Drawing Amendments

The attached sheets of drawings includes changes to Figures 7 and 8, as described below, as well as corrections required by the USPTO draftsman. These sheets replace the original sheets.

Fig 7

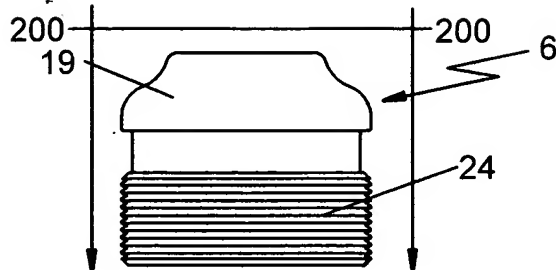
In Figure 7, the reference number identifying the nut is mistakenly labeled 27. A corrected drawing is attached which correctly labels the nut with reference number 31. This reference number is supported in the specification on page 5, line 10.

Fig 8

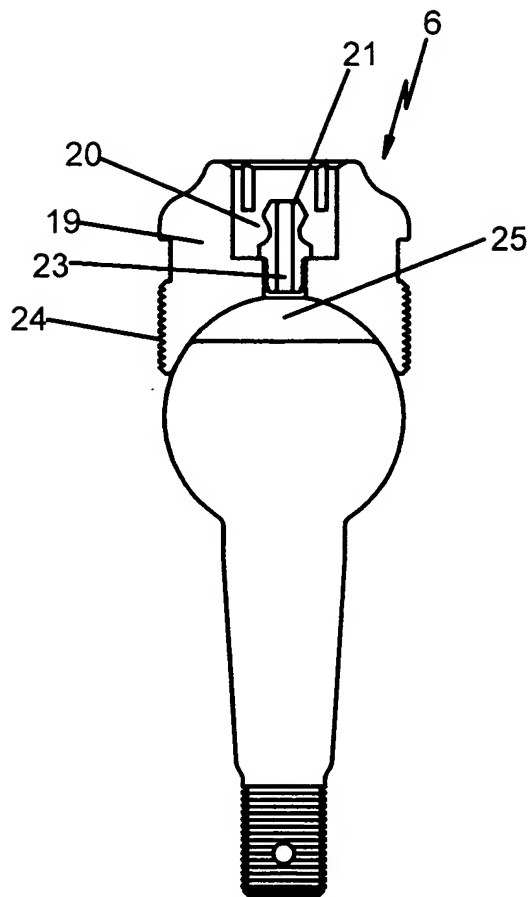
Figure 8 has been amended to show the ball within the retaining member, and to indicate the location of the void (reference number 25) between the truncated surface of the ball and the interior of the retaining member. No new matter has been added since the relationship of the ball within the retaining member and housing, including void 25, is described in the specification on page 6, lines 1-14.
